MEMORANDUM

Subject: Rezoning, Preliminary and Final Development Plans, Preliminary and Final Plat,
Platting Variance to defer Park Dedication Fees, and Conditional Use Permit for the
Sick Technology Campus

Kimley-Horn has reviewed the comments provided by the City of Bloomington dated February 16, 2021 and has modified the plans accordingly. The comments and responses are listed below. Responses to comments are in ***bold italics***.

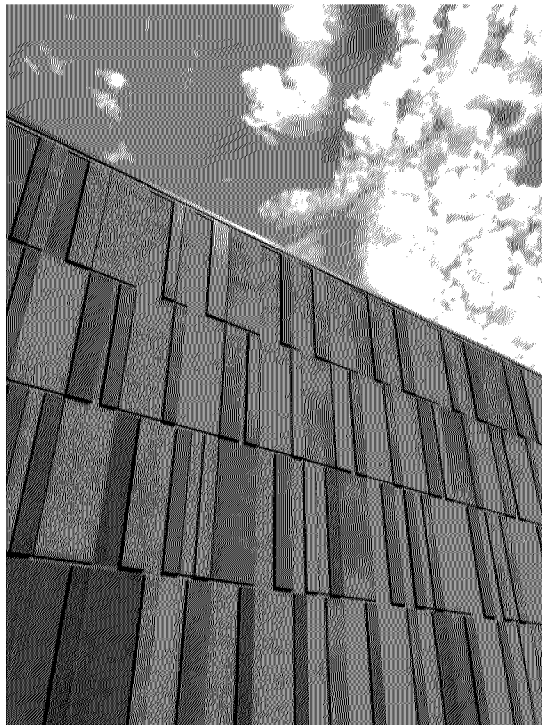
11. Exterior materials must meet Section 19.63.08. The proposed materials, pre-cast architectural concrete panels require a deviation from City Code. Please provide additional detail on the proposed panels.

The precast architectural concrete panels being proposed are a combination of acid-etched, polished and sandblasted charcoal grey/black concrete, in combination with Structurally Glazed (butt glazed) curtain wall systems. The precast concrete is a high-quality and durable finish in keeping with the standards of the City of Bloomington for developments in this area. Large portions of the concrete will be polished to a reflective finish resembling polished granite. See image below from a completed project with similar finishes.
